Product Change Notification

June, 2008

Change in Height of Model 6100 Inductor

Revised Height

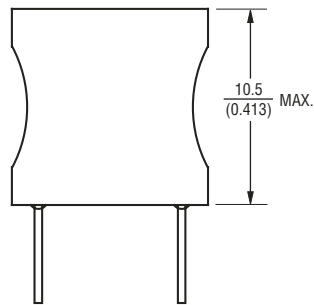
Effective October 1, 2008, the maximum mounting height of **Model 6100** will be 12.0 mm (0.472 inch) maximum. The current mounting height is 10.5 mm (0.413 inch) maximum.
